## 产品变更通知

PCN # 编号: Telink PCN-2024-001

Device affected 受影响的芯片: TLSR8373AER、EP3S41T16ER

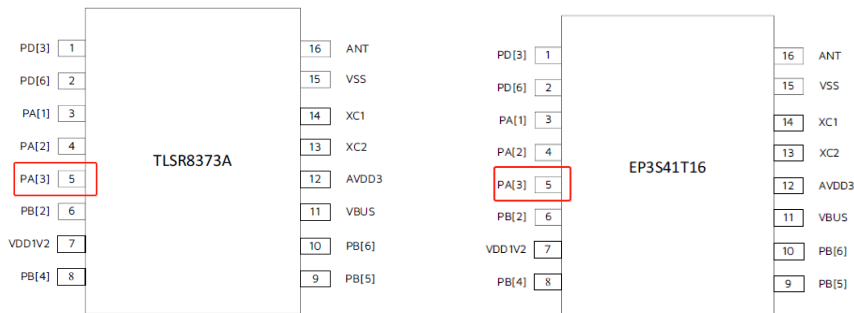
The chip version was changed from A1 to A4, and the fifth pin name of the chip was changed from PB(0) to PA(3). The picture of fifth pin of device TLSR8373AER / EP3S41T16ER after change as below.

芯片版本从A1变更至A4，芯片的第5管脚名字从PB(0)变更至PA(3)。

TLSR8373AER / EP3S41T16ER 第5 Pin 脚变更后图片如下:

Convenient for customers to debug when using USB, lead out the SWS pin PA(3).

变更原因: 方便客户在使用USB时调试，引出SWS管脚 PA(3)。
